Subject: Response to Planning Board

WSP USA Inc. ("WSP") and BWC Wades Stream, LLC ("BlueWave") received questions and comments at the 7/14/2026 Worthington Planning Board Public Hearing. WSP and BlueWave have prepared the following responses and supporting documentation for consideration by the Board. To note, an updated plan set is included as Appendix A of this submittal.

PROJECT: 2.0 MW AC GROUND-MOUNT SOLAR PV DEVELOPMENT 190 RIDGE ROAD WORTHINGTON, MA 01098

SUBJECT: Acoustic Analysis - Proposed Solar Facility (revision 2)
Ridge Road, Worthington, MA

Figure 4

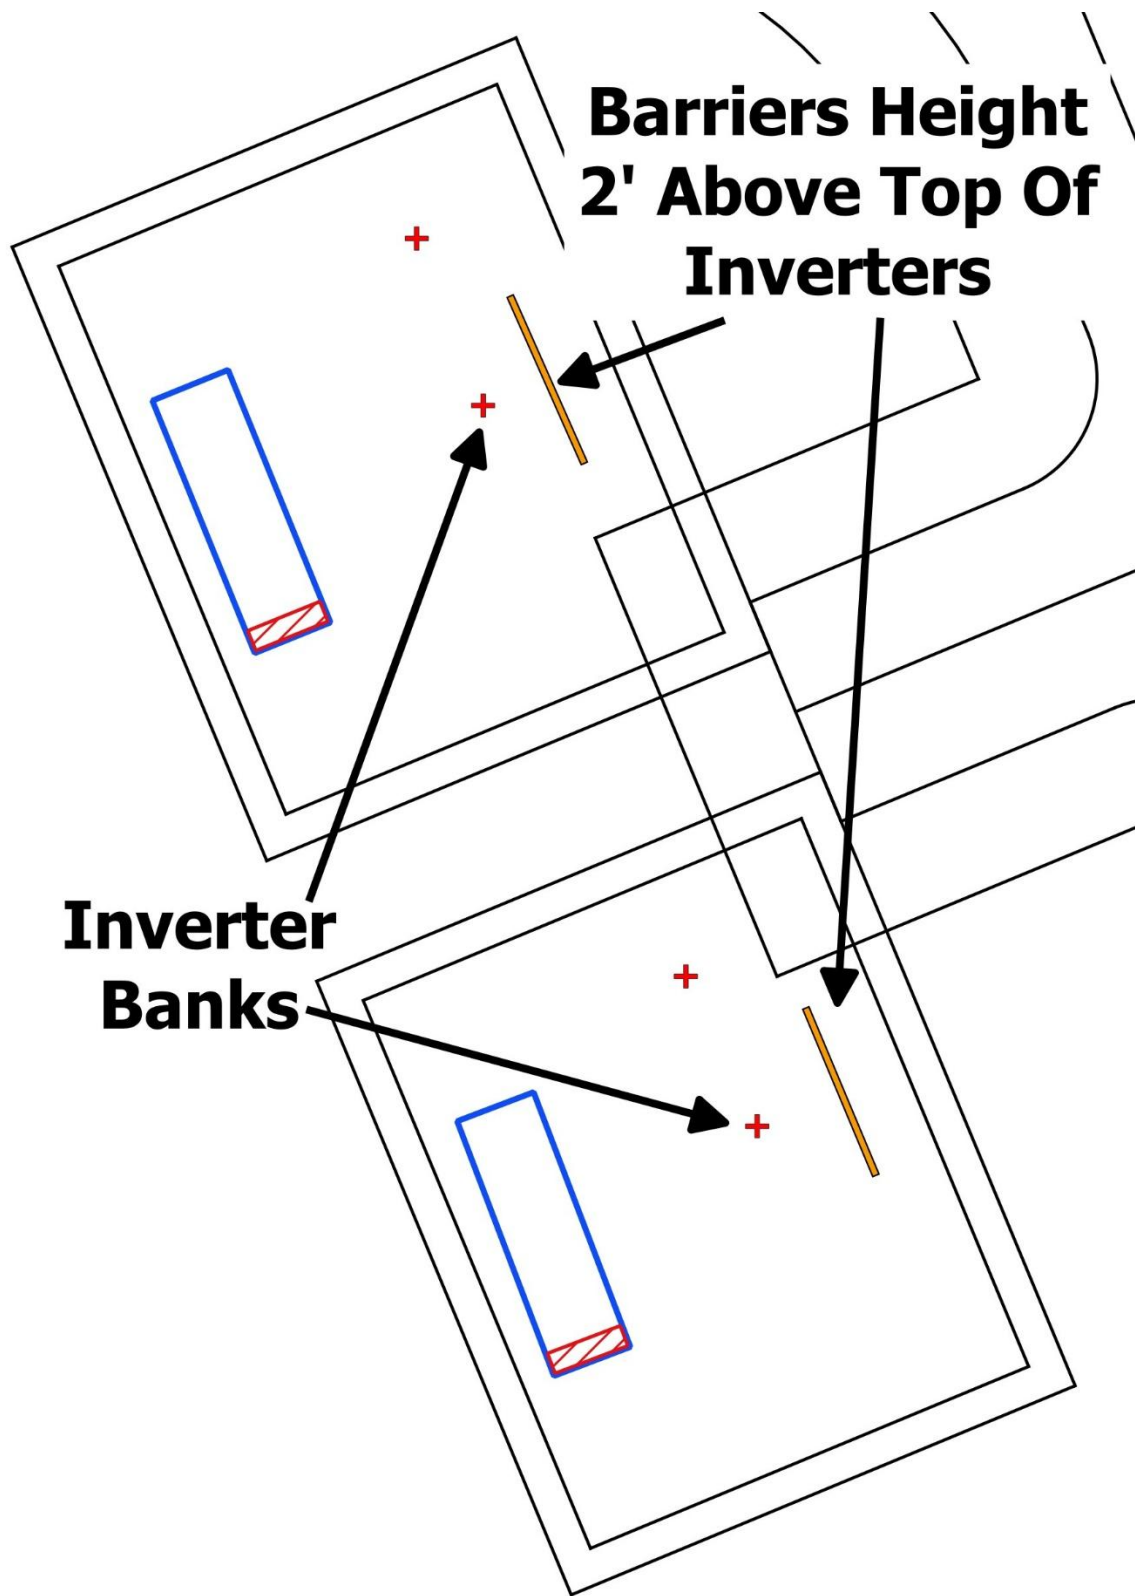
3. The acoustic analysis should revise the receptor location at the 140 Buffington Hill Rd Property

Response: The Acoustic Analysis has been revised accordingly, see Appendix C. There is no material impact.

Figure 4 presents the results of the acoustic modeling for the proposed Project. Table 2 provides a summary of our estimates of Project A-weighted sound levels at relevant receptors. Daytime sound levels exceed MADEP limits at one of the modeled receivers. For compliance with the applicable regulations, sound mitigation measures are warranted.

Figure 5

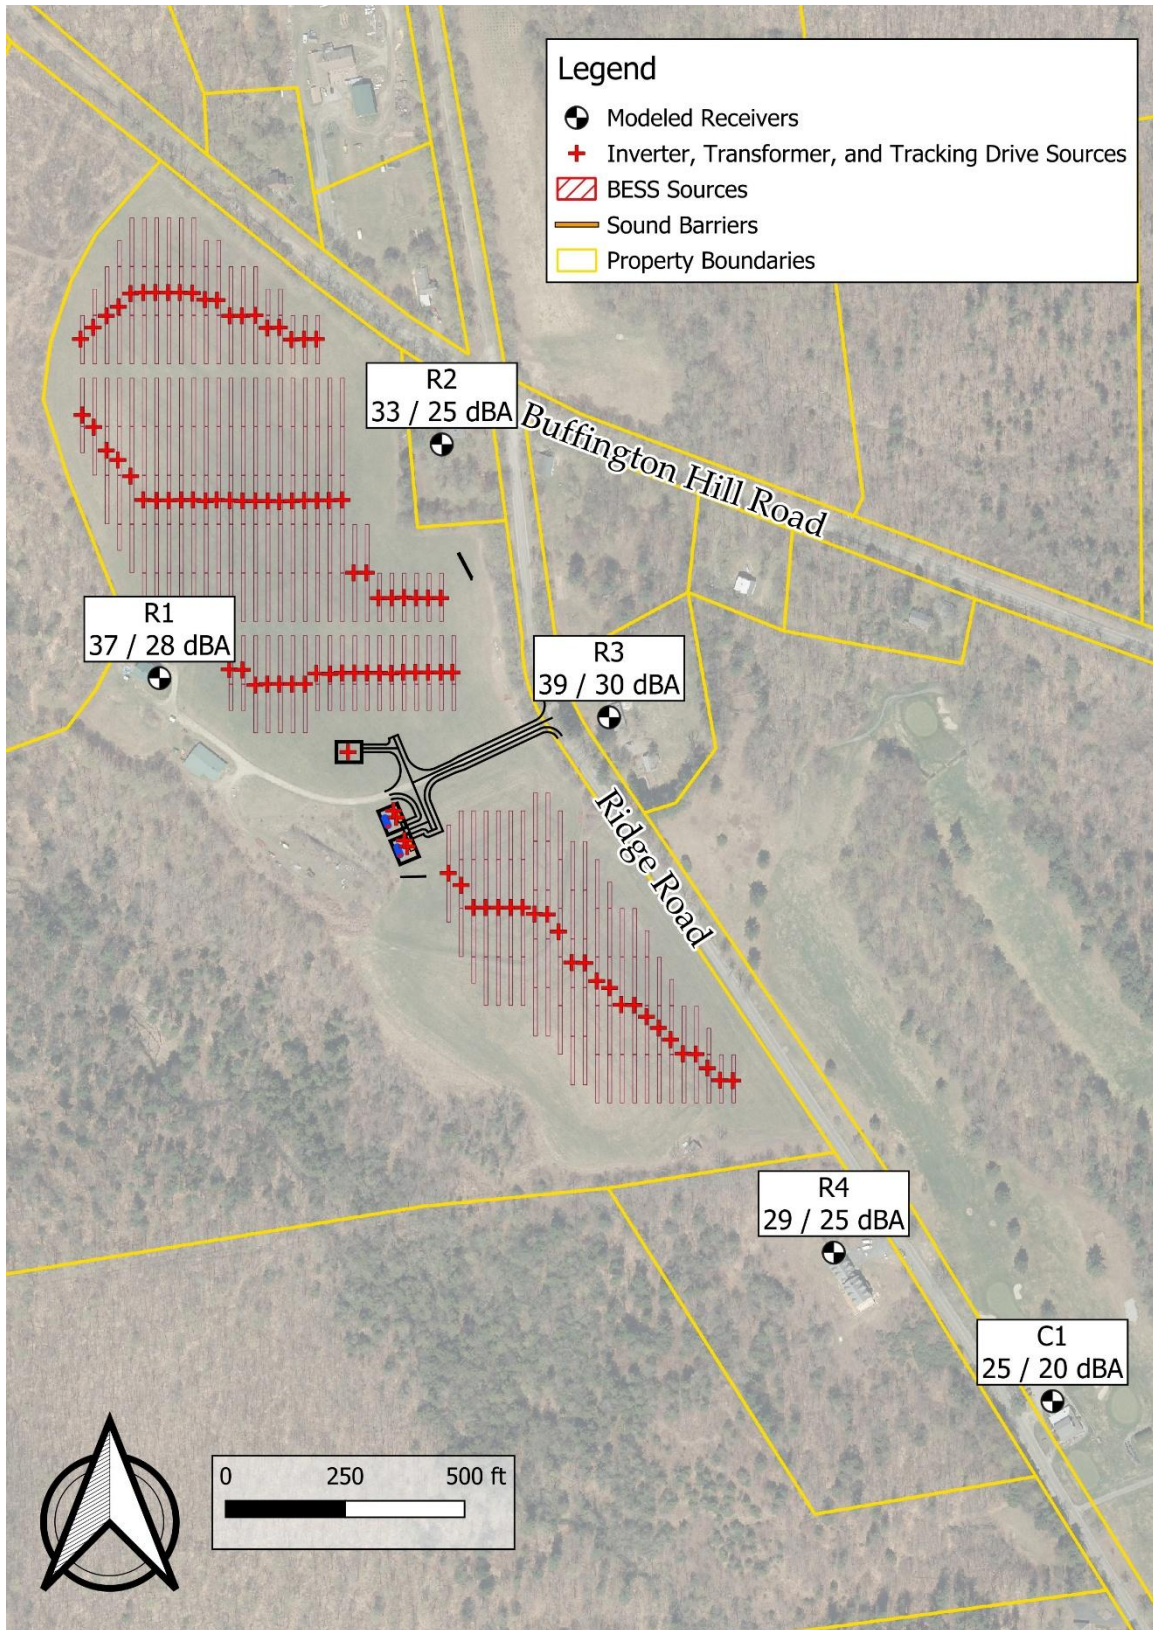
Full compliance with the applicable noise regulations will require mitigation. We recommend implementing sound barriers as shown in Figure 5. The barriers on the east side of the central and south inverter banks, with height 2 feet above the top of the inverter units.

Inverter bank configuration has not yet been determined, but the barrier segments should be located on the sides of the inverter bank indicated, and positioned as close to inverters as allowed by equipment clearance requirements. We will provide updated barrier configuration when equipment pad layout is determined.
